Parts Manual

Series 90

55cc Axial Piston Pump

Contents
Service bulletin

Servo arm change

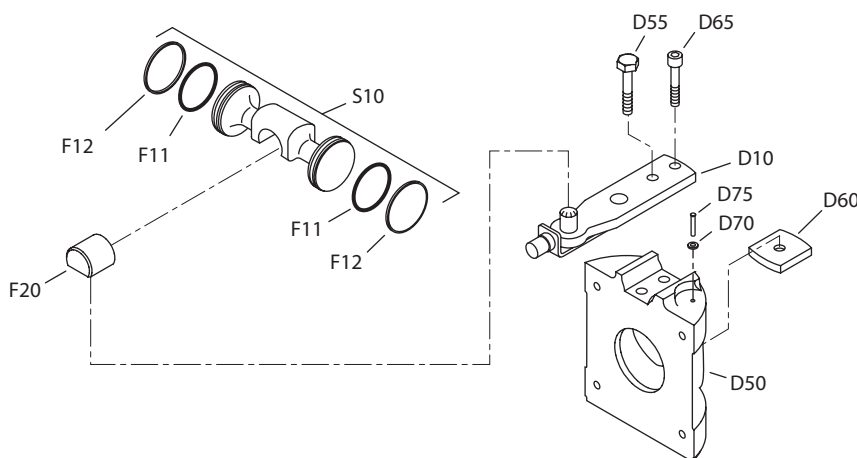
As a product improvement, Sauer-Danfoss has changed the series 90 pump servo arm and swashplate (item D10 and D50). The old style servo arm and swashplate will become obsolete. Because this change creates non-interchangeability between new and old swashplates, servo arms, and possibly servo piston (item S10) and slider block (item F20), separate servo arms and swashplates will no longer be sold as service parts.

Also, the new servo arm is actually a press fit into a groove in the new swashplate. This situation requires special tooling for assembly, therefore, pre-assembled kits will be created for 55, 75, and 100 cc pumps. The kits will work in any vintage pump.

The kit for 55 cc pumps will include all the items in the figure, except item S10

The kit for 75 cc pumps will include all item in the figure.

The kit for 100 cc pumps will include all items in the figure, except items S10 and F20.

Change goes into effect with s/n 88-14-xxxxx on 55 cc pumps and with s/n 88-16-xxxxx for 75 cc and 100 cc pumps.

Change to fixed clearance slipper hold down

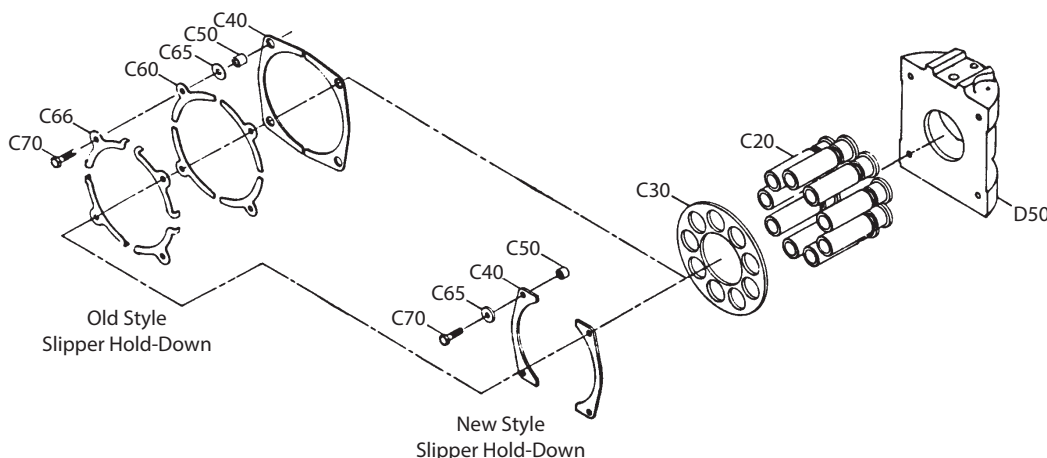
As a product improvement, Sauer-Danfoss has simplified the design of the series 90 pump slipper hold down mechanism. The hold down changes from spring loaded with a fixed maximum clearance design.

The leaf spring (item C60) and spring aligner (item C66) will be eliminated and will not be available as service parts.

The spacer (item C50), bearing (item C40), and washer (item C65) will change and the old part numbers will not be available as service parts.

Remote pressure filtration adapter change

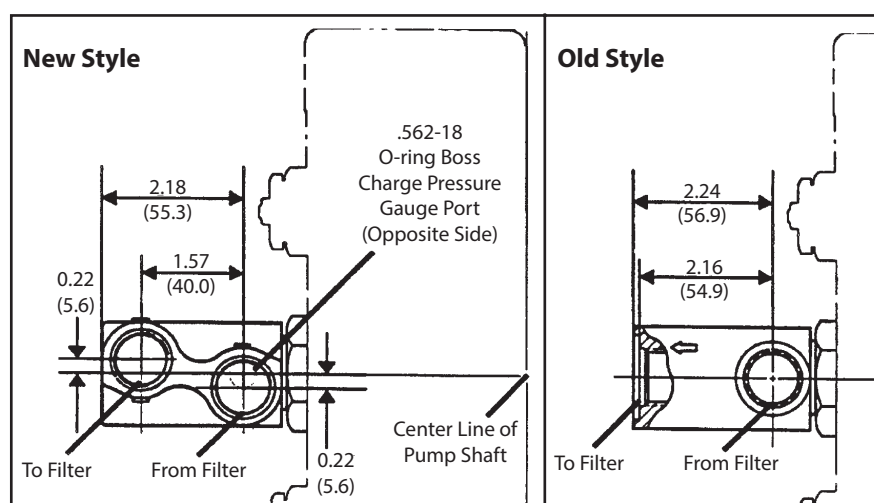
The configuration of the remote pressure filtration adapter, available as an option on Sauer-Danfoss series 90 variable pumps (55, 75, and 100 cc) is changing. This improved design adapter incorporates a charge pressure test port. In addition, the remote filter connections have been relocated to improve the customer interface and the routing for filter plumbing on most applications. Port sizes did not change. (A version of the improved design adapter is already being used on Series 90 42 cc variable pumps.)

This change does not affect the pump end cap, and either design filtration adapter can be used on any vintage pump. Only the new style adapter will be available as service parts or on new production pumps.

Charge pump design change

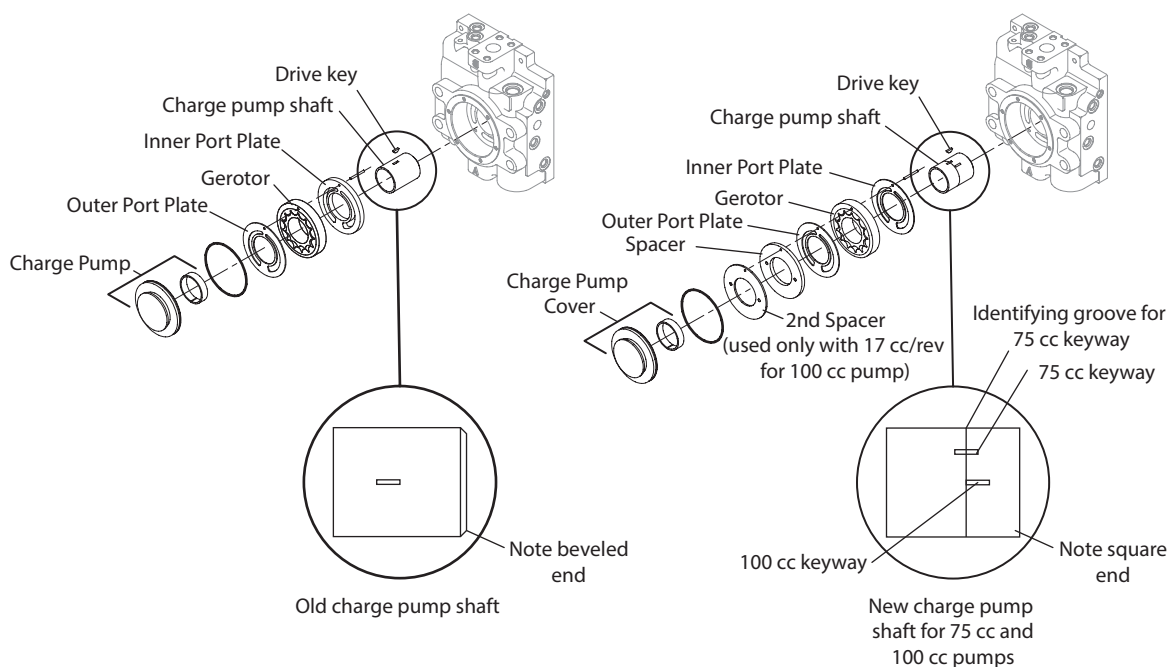
Models affected	All 94-2xxx (55 cc), 95-2xxx (75 cc), and 96-2xxx (100 cc) pumps
Serial numbers	A-89-17-xxxxx for all pumps manufactured in Ames, Iowa. N-89-07-xxxxx for al 95-2xxx (75 cc) pumps manufacture in Neumunster, West Germany. N-88-48-xxxxx for all 96-2xxx (100 cc) pumps manufacture in Neumunster, West Germany.
Part numbers affected	Proper part number versus pump serial number information can be found in the series 90 Parts Manuals. The thicker inside port plates (thicker than 0.050 in (1.27 mm) will be obsoleted and no longer available as service parts. If these parts require replacement, use the 0.050 in. 1.27 mm) port plate and appropriate spacer(s) as service parts. On 100 cc pumps only, the new charge pump shaft must be used if the new style spacer is used, On 55 and 75 cc pumps, the charge pump shaft clearance pocket in the end cap changed from a beveled to a straight corner to correspond with the change in the charge pump shaft. Old style charge pump shafts will remain available as service parts and must be used in the 55 and 75 cc beveled pocket end caps. Old style (beveled pocket) end caps will be obsoleted and no longer available as service parts. If an old style end cap needs replacement, new style end caps can be used with any vintage charge pump hardware and charge pump shaft.

Parts disposition	■ Non-interchangeable - must use correct charge pump shaft per serial number of pump

Change takes place at serial number A-89-17-xxxxx.

End cap and housing change

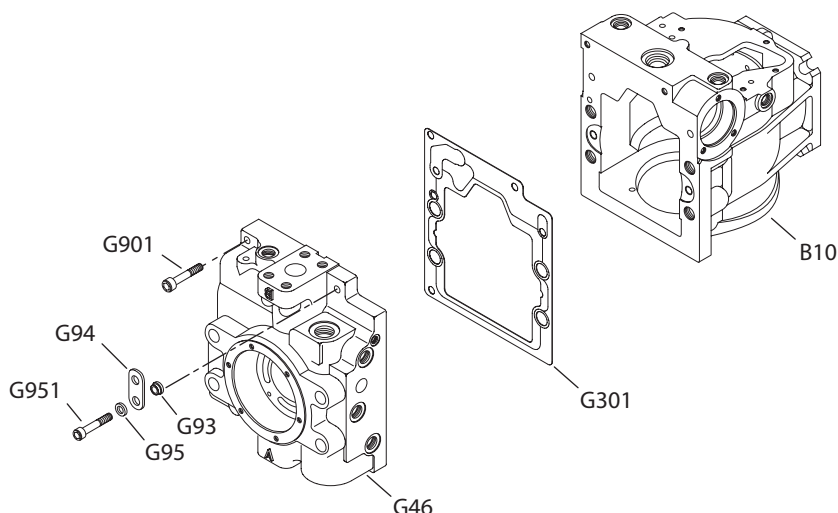
Change takes place at serial number A-89-47-xxxxx.

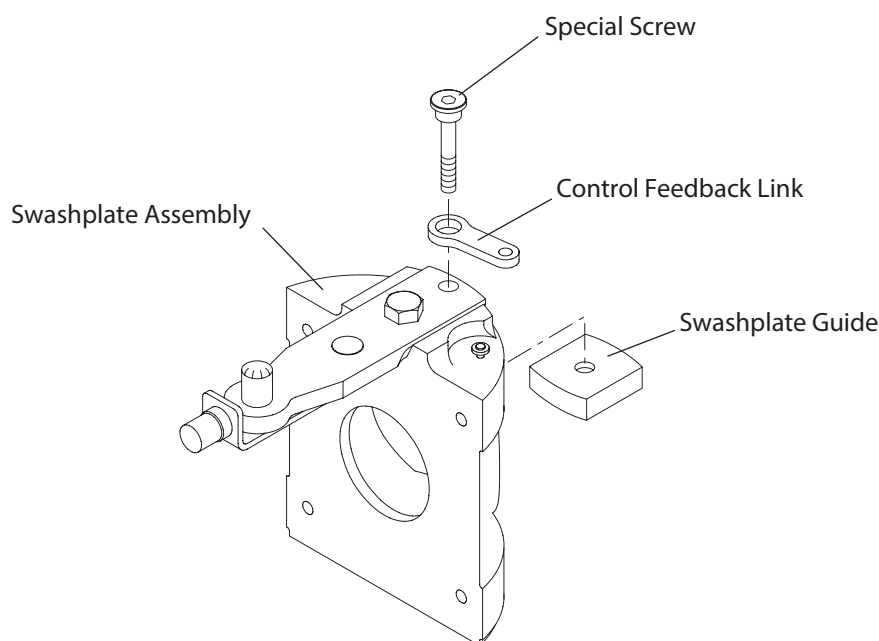
Effective in September of 1992, the feedback link in series 90 pumps will be mechanically retained to the swashplate. In the past, the link slipped over a specially ground socket head screw and could fall off the screw during assembly. The screw has changed to include a head to retain the link. The feedback link does not change.

Service Bulletin: SB-1994-017

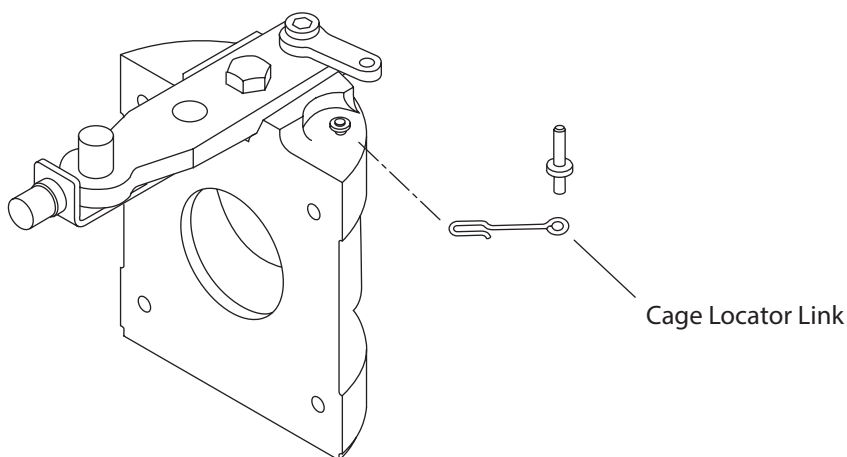
Description As a product improvement, Sauer-Danfoss has made a design change to the cage locator link used on the 55 thru 100 cc variable pumps.

The new link is made from square wire. In the past, the link was made from round wire. This is an interchangeable change.

Side cover washer elimination

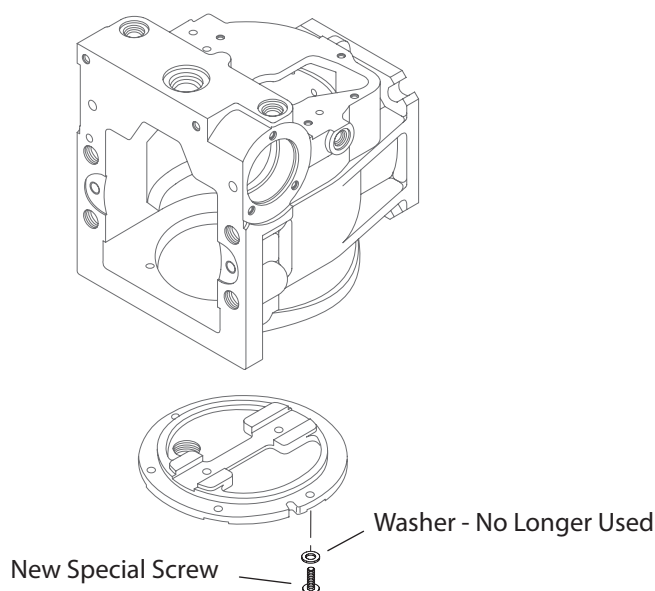
Change took place during the 2nd and 3rd quarter of 1994

Integral filtration manifold

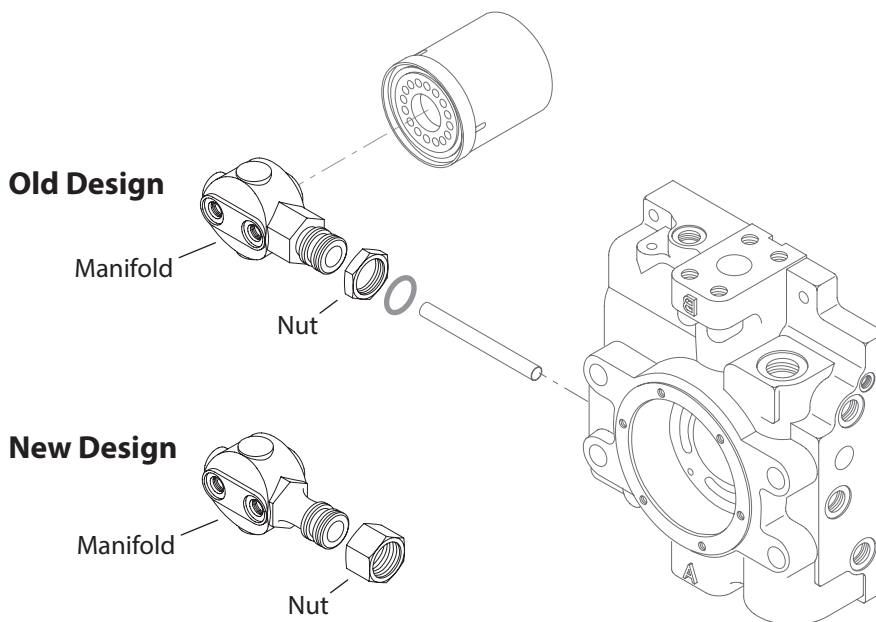
Change occurred at serial number 95-18-xxxxx

Subject Swashplate bearing cage locator pin

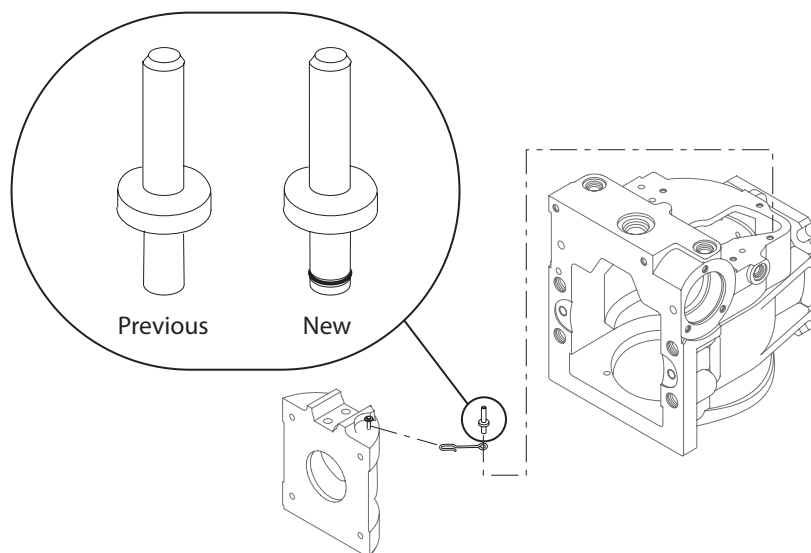
Description Sauer-Danfoss has modified the design of the swashplate bearing cage locator pin used in the series 90 55, 75, and 100 cc variable displacement pumps.

To aid in identifying this change, Sauer-Danfoss has released a new part number for the updated pin design. The new pin is completely interchangeable with the previous pin part number. The previous pin has been obsoleted.

Serial numbers This change became effective at serial number 98-24-xxxxx

Charge pump shaft part number change

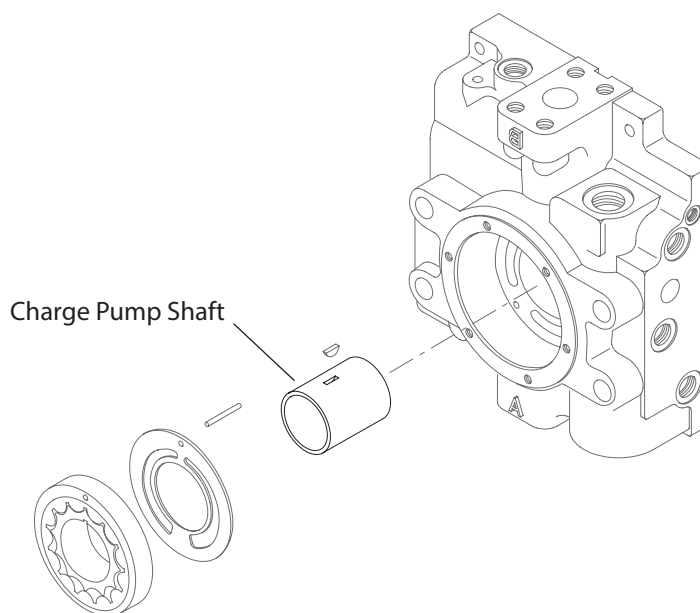
As a product improvement, Sauer-Danfoss has modified the design of the charge pump shaft used in series 90 55, 75 and 100 cc pumps. This change affects all charge pump sizes (11, 14, 17, 20, 26, and 31 cc) available in the series 90 displacement range.

The design modification includes a surface finish change to the charge pump shaft which improves the wear characteristics between the charge pump shaft and the journal bearings in the charge pump cover and end cap.

To assist in identifying this change, Sauer-Danfoss has released new charge pump shaft part numbers. The new shafts are completely interchangeable with the previous shafts. The new shaft has replaced the previous shaft in new pump assemblies and charge pump service kits. The previous shafts have been obsoleted and are no longer available as a service part. The chart on the next page will assist you in determining the part number changes.

NOTE: Pump models 9621723 and 9622117 were released with a special charge pump option (code W - 26 cc charge pump with special shaft). With this product modification, the charge pump option code for these two models has been changed from W to the standard option (code F - 266 cc charge pump). The special shaft part number 8801176 has been obsoleted and replaced with shaft part number 8801178.

Auxiliary flange charge pump cover

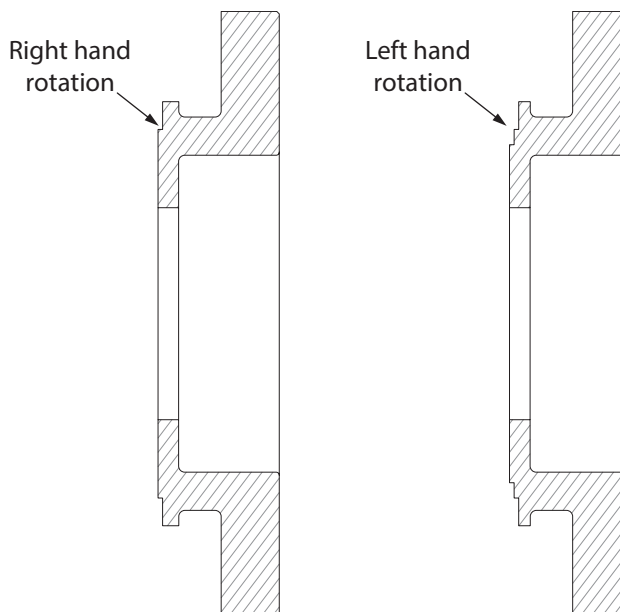
The part numbers of the charge pump covers will not change.

This change became effective at serial number A-05-17-xxxxx

Subject SAE C auxiliary mounting flange

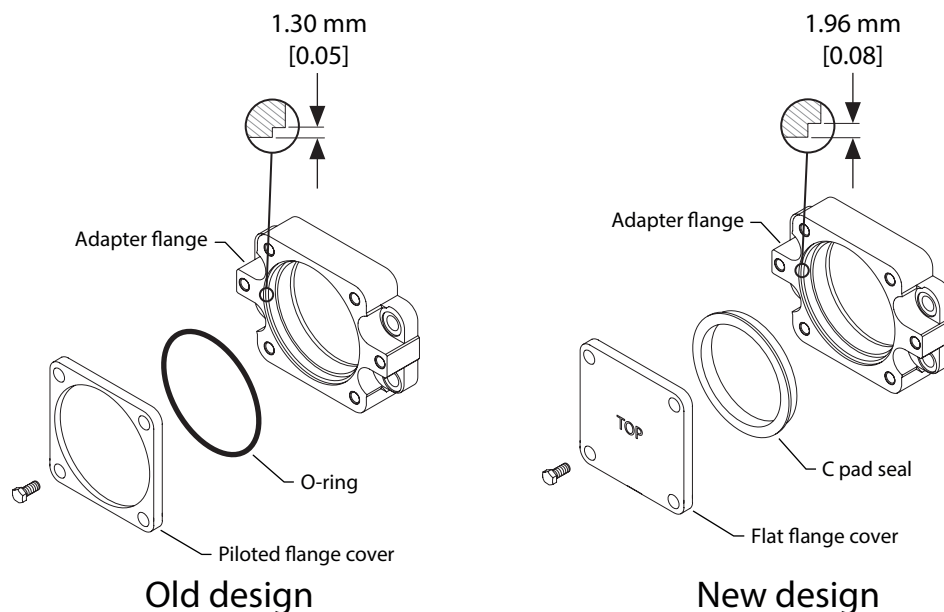
Part numbers affected Sauer-Danfoss is pleased to announce a design improvement on the SAE C auxiliary mounting flange adapter on its series 90 pumps. The frame sizes affected by this change are 55, 75, and 100cc. All manufacturing locations producing these pumps will be changed to this configuration.

The pumps will now be supplied with the donut style seal and new flat cover, instead of the small O-ring and cover plate (shown in the drawing below).

This change became affective at serial number; A 08-19-xxxxx and N 09-30-xxxxx.

Subject SAE B auxiliary mounting flange

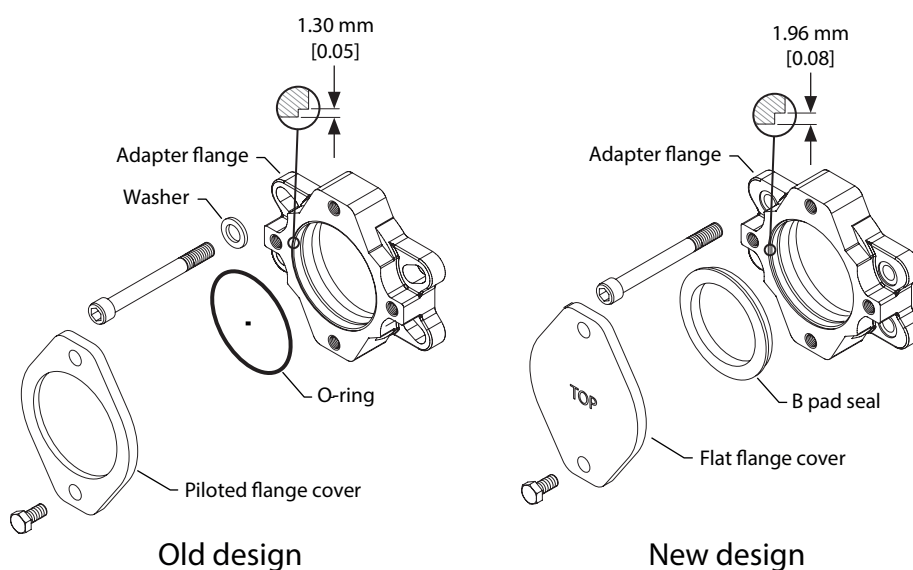
Part numbers affected Sauer-Danfoss is pleased to announce a design improvement on the SAE B auxiliary mounting flange adapter on its series 90 pumps. The frame sizes affected by this change are 55, 75, and 100cc. All manufacturing locations producing these pumps will be changed to this configuration.

The improvement comes in the form of a more robust sealing geometry with a larger cross-section O-ring. The O-ring groove in the flange will now be sized to mate with a 2.62mm [0.103] cross section O-ring rather than the old 1.78mm [0.070] cross-section O-ring. The Sauer-Danfoss part number for the new O-ring is 9004104-1540 (2.62mm [0.103] x 94.92mm [3.737]). The larger cross-section sealing geometry allows for the use of a donut style B pad seal and a new flat cover for improved assembly. This new configuration is qualified as a running cover. When installing an auxiliary pump, the donut style B pad seal must be discarded and part number 9004104-1540 O-ring used.

Also, the flanges will no longer have a slotted interface with a washer for the end cap screws. The flanges will now have round through holes for the end cap screws and will use no washers. The end cap screws do not change. This eliminates the area where water or high pressure wash chemicals can be trapped around the end cap screws. There now are specific part numbers for the flanges used on each of the three displacement size pumps; 55, 75 and 100 cc.

The pumps will now be supplied with the donut style seal and new flat cover, instead of the small O-ring and cover plate (shown in the drawing below).

Serial numbers This change became affective at serial number; A 08-19-xxxxx.
